**REMARKS**

"ANNOTATED SHEET SHOWING CHANGES"

FIG. 1

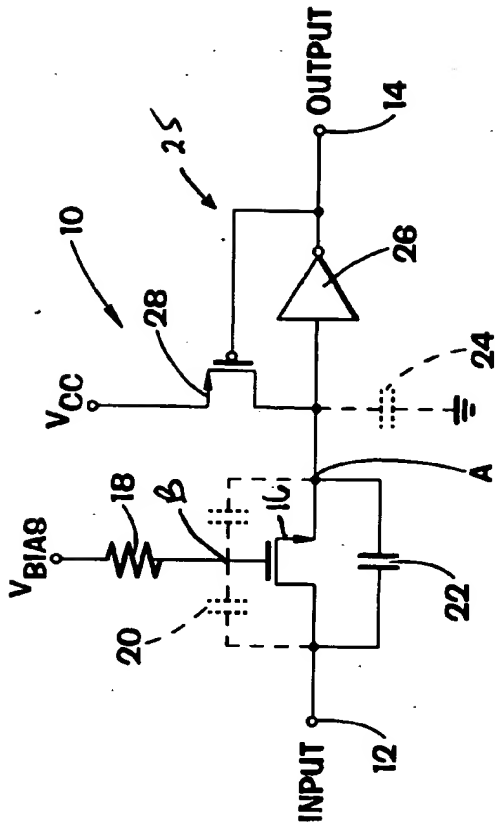
Corrected formal drawings are being submitted here, in which missing reference numerals "B", "16", and "25" have been inserted into Figs. 1 and 2, as discussed in the specification as filed, paragraph bridging pages 5-6, and at page 7, first paragraph (buffer circuit 25). No new matter has been added.
